ADDENDUM No. 1***November 7, 2016***

HOPMEADOW STREET
SANITARY SEWER
Project WPCA 16-04
Simsbury, Connecticut

PERMANENT TRENCH REPAIR

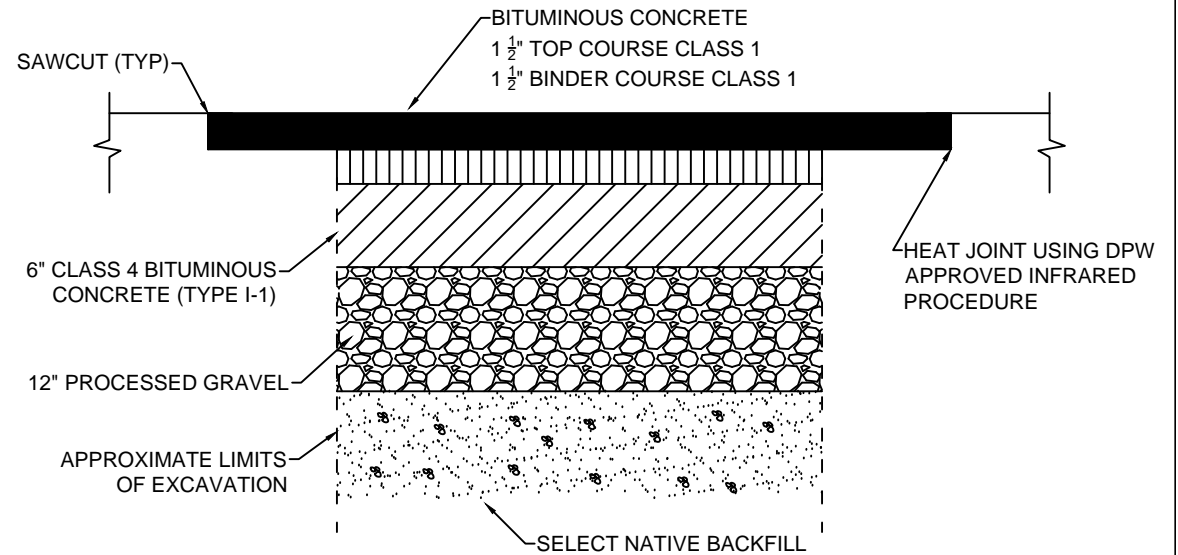
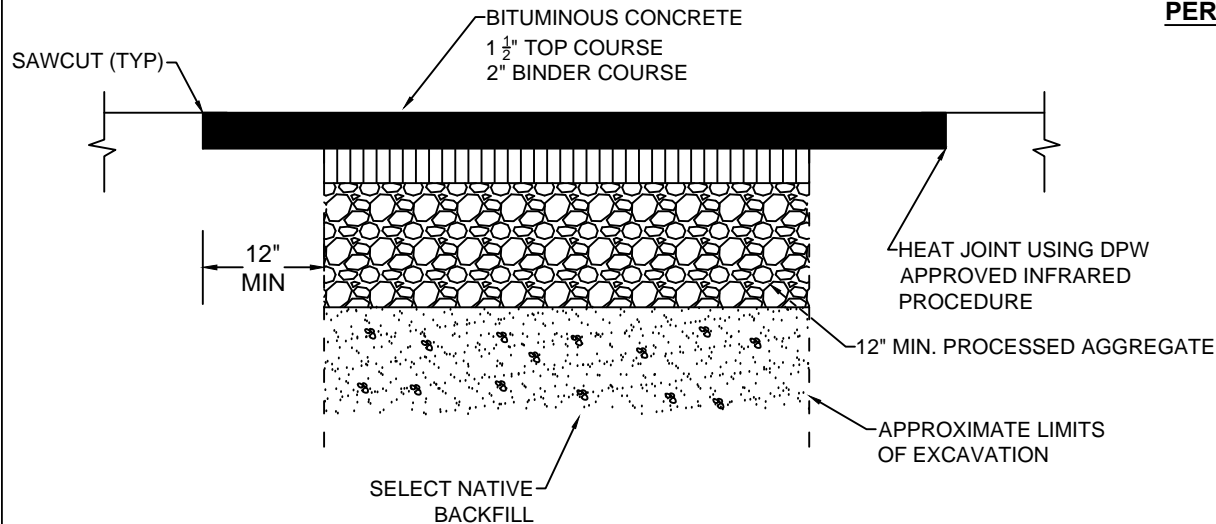
Details for the restoration of route 10 have been provided to clarify the States restoration requirements.

4. Question: Are manholes to be supplied with this contract?
Answer: Manholes are to be supplied and installed as indicated in Division III.
5. Question: Do we need to follow state specifications when paving route 10/Hopmeadow Street?
Answer: Paving of Route 10 / Hopmeadow Street is subject to requirements of CT DOT permit. Night work may be required for the crossing. A new pavement detail is provided for work within the State Right of Way and for additional pavement requirements.
